**ENTERGY OPERATIONS INCORPORATED
ARKANSAS NUCLEAR ONE**

**TITLE: EMERGENCY ACTION LEVEL
CLASSIFICATION**

DOCUMENT NO.
1903.010

CHANGE NO.
037-02-0

Attachment 7 (0CNA080005)
Unit 1 Fuel Cladding Failure Radiation Plot
 mRem/hr at SA-229

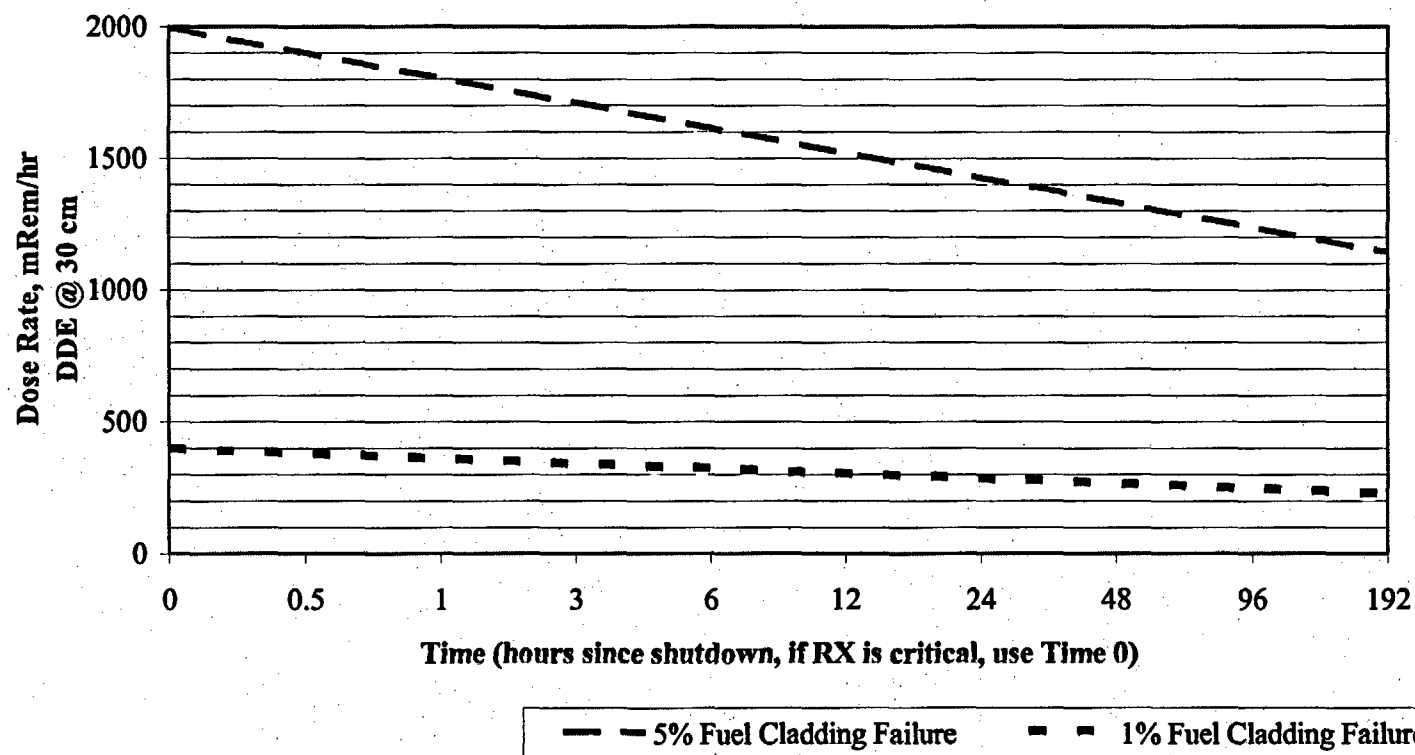
Added note "If RX is critical, use Time 0" to graph to give the operators guidance for usage of the graph.

NOTE: If RX is critical, use Time 0

Attachment 8 (0CNA080005)
Unit 2 Fuel Cladding Failure Radiation Plot
 mRem/hr at 2TCD-19

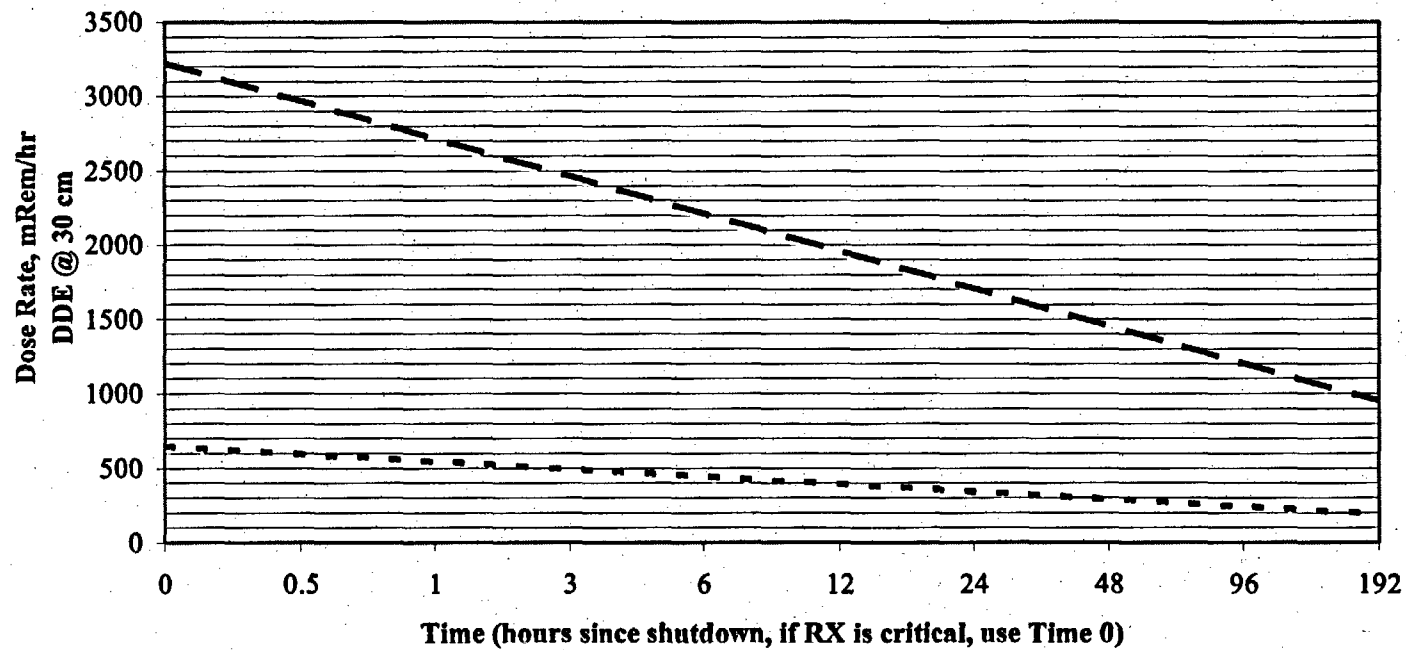
Added note "If RX is critical, use Time 0" to graph to give the operators guidance for usage of the graph.

NOTE: If RX is critical, use Time 0
